YUCCA MOUNTAIN - SUPPLEMENTAL RESPONSES TO REQUEST FOR ADDITIONAL INFORMATION - SAFETY EVALUATION REPORT, VOLUME 3, CHAPTER 2.2.1.2.1 (SCENARIO ANALYSIS), 4TH SET (U.S. DEPARTMENT OF ENERGY'S SAFETY ANALYSIS REPORT SECTION 2.2.1.2)

RAI Volume 3, Chapter 2.2.1.2.1, Fourth Set, Number 23, Supplemental Question:

RAI Volume 3, Chapter 2.2.1.2.1, Fourth Set, Numbers 35 and 41, Supplemental Question:

Figure 1. POC for DOE and Commercial SNF as a Function of Critical Limit

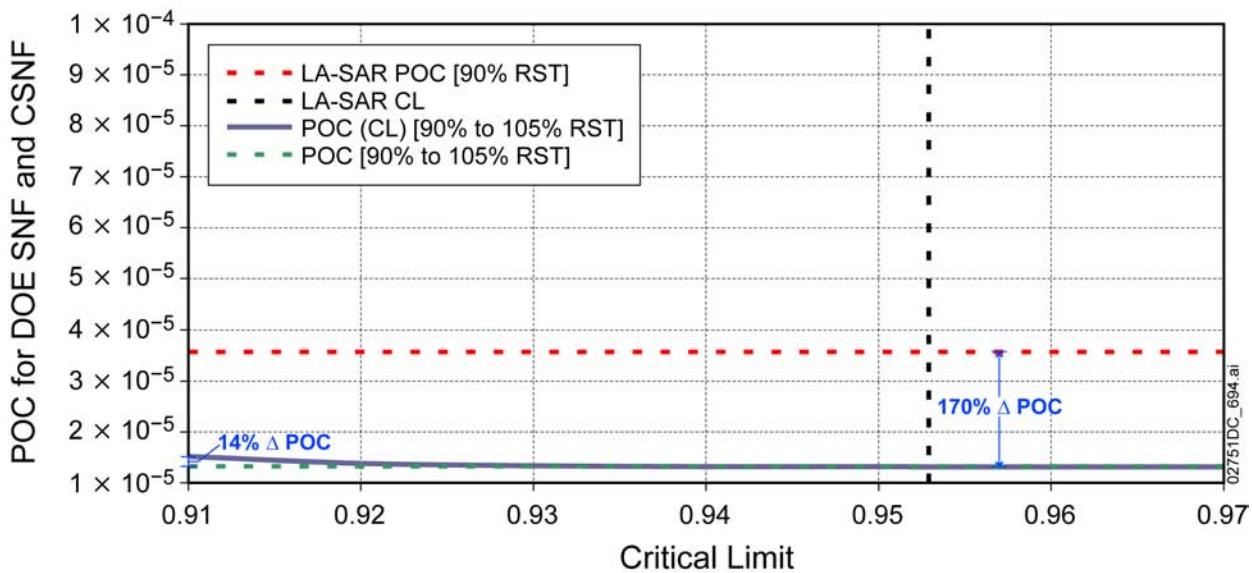
Where in the responses to RAI 3.2.2.1.2.1-4-035 and RAI 3.2.2.1.2.1-4-041 did DOE provide detailed technical justification for the use of zero administrative margin to ensure subcriticality? These RAIs requested one of the following:

- (a) Demonstration that intact and degraded spent nuclear fuel (SNF) configurations will be subcritical in the postclosure period, including the use of a subcritical margin of 0.02.
- (b) Demonstrate that the combined conservatism in modeling assumptions for each configuration exceeds 0.02 Δk_{eff} .

A demonstration of how much excess margin has been incorporated is illustrated in Figure 1 for just one bounding parameter (there are several) in the POC calculation - probability of damage due to seismic vibratory ground motion (P_D). The POC used in the license application for criticality feature, event, and process screening (represented by the red dashed line in Figure 1) conservatively uses the damage frequency to the waste package outer barrier based on a 90% residual stress threshold (RST) to determine the probability of stress corrosion cracking (SCC) breach, within 10,000 years, as a result of seismic vibratory ground motion (P_D). The RST is

expressed as a percentage of the yield strength and represents a threshold value for the stress in the waste package outer barrier when SCC could form. The use of only the 90% RST value in the damage probability estimates is conservative because *Stress Corrosion Cracking of Waste Package Outer Barrier and Drip Shield Materials* (SNL 2007, Table 8-3) indicates that the SCC crack initiation stress threshold criterion for alloy 22 (i.e., the waste package outer barrier material) follows a uniform distribution between 0.9 and 1.05 YS_T where YS_T is the at-temperature yield strength. Therefore, use of the 90% RST maximizes the damage frequency (see Table 1). Using the integrated damage frequency over the 90% to 105% RST distribution to determine the probability of stress corrosion cracking breach (values are listed in Table 1), which is analogous to using the mean of the distribution range as prescribed in NUREG-1804 (NRC 2003, p. 2.2-14), results in a POC illustrated by the green dashed line in Figure 1. Changes to the POC from varying the critical limit (i.e., simulating the use of administrative margin on k_{eff}) over the range from 0.91 to 0.97 are illustrated by the purple line in Figure 1 which has been averaged over RST. As can be seen, the effect of varying the critical limit on the POC is negligible compared to the effect of using a fixed value of 90% for the RST (illustrated with the red dashed line in Figure 1). The use of a damage frequency for 90% RST instead of the average damage frequency over RST results in an increase to the POC of 135% to 170% for critical limits of 0.91 to 0.97, and is bounding over any impact from changing the critical limit (~14% change at a critical limit of 0.91).

Consequently, because the 10 CFR 63.342(a) requirement for FEP screening is expressed as a probability criterion, a means to provide an allowance for any unknown (or difficult to identify or quantify) error or uncertainties has been incorporated through the use of bounding probability values in the POC calculation in lieu of using an administrative margin on k_{eff} that has a negligible influence on the POC calculation. The effects on the POC are illustrated in Figure 1 by comparing the red dashed line with the purple line and demonstrate that the conservatism used is much larger than the effect of 0.02 Δk_{eff} change on the critical limit.
